## **RESPONSES TO ACCOMPANY 25 APRIL RESUBMITTAL**

## RESPONSES TO ACCOMPANY 12 APRIL SUBMITTAL

# SANCTUARY INTERSTITIAL DEVELOPMENT AND VIEWS BALLROOM EXPANSION

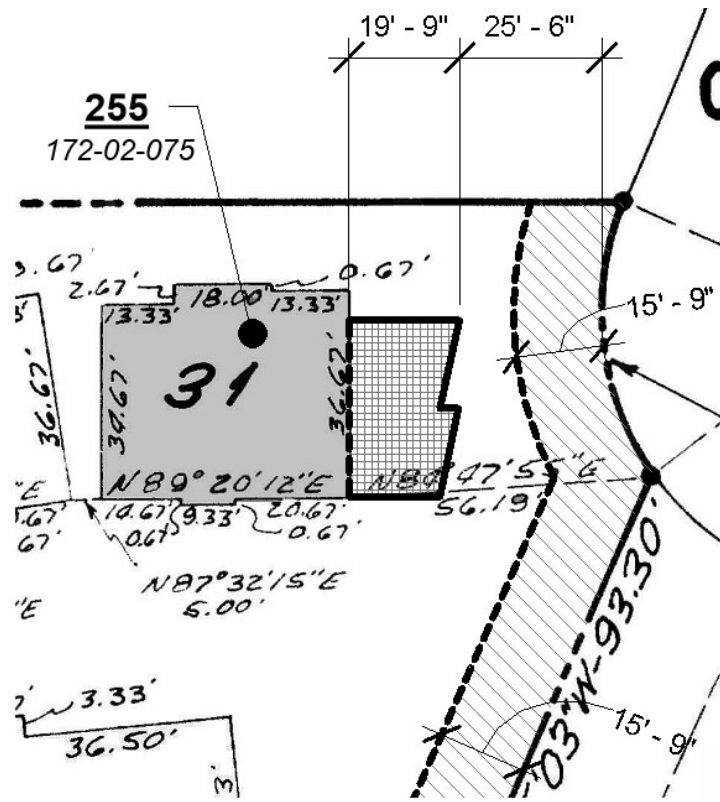
2.1) The existing parcel spacing precedent condition in the current SUP along a roadway is 15'-9" (established at hillside casita parcel 24 (172-02-068)). All proposed hillside casita improvements (as shown in hatched area) along Superstition Lane exceed the parcel spacing precedent condition.

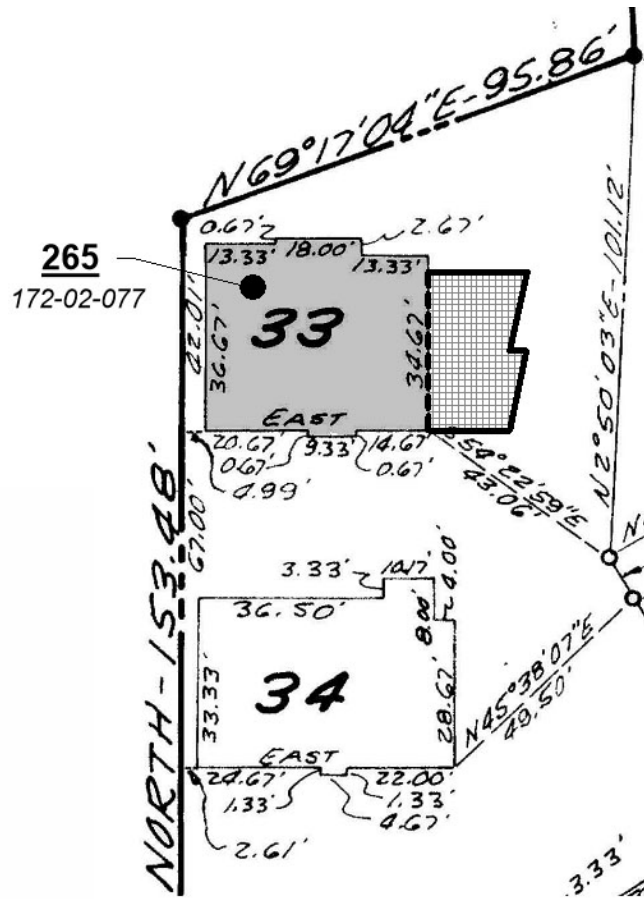
2.2) Hillside casita parcel 31 (172-02-075; Sanctuary Casita 255), lies well within the precedent condition under the current SUP. The proposed improvements are on the east side of the parcel. Currently there exists 45'-3" parcel spacing between the east property line and the Superstition Lane ROW. When the legal description of the parcel is amended to modify the footprint, there would remain a distance more than 25' between new property line and ROW, exceeding the 15'-9" of existing parcel spacing precedent.

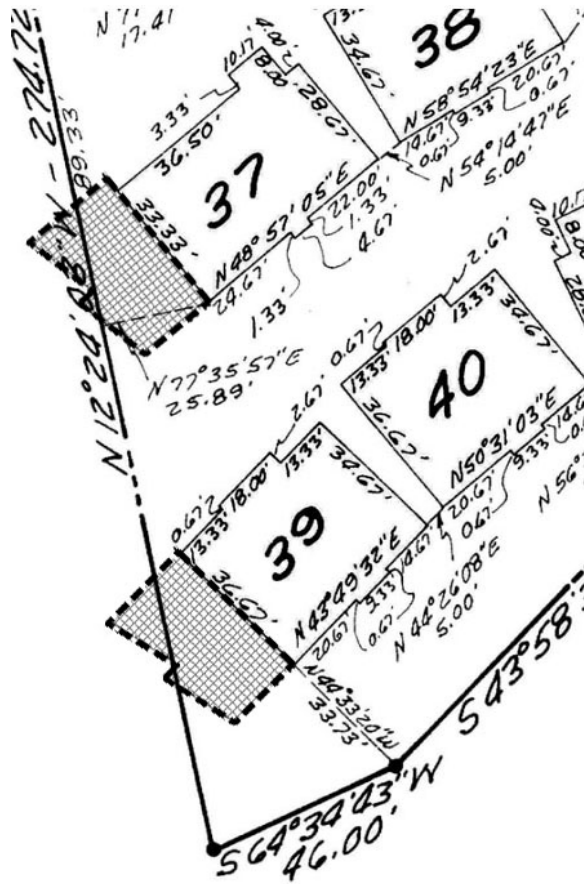
2.3) Following the precedent condition of the existing hillside casita parcels adjacent to a property line shared with another Sanctuary property line, the parcel spacing precedent established is 2.61'. [see below: parcel 34 (172-02-078) and the property line of the Sanctuary Gallery House (172-02-088)]. The proposed keys in this case, shown as the hatched area, are within the current SUP parcel spacing precedents.
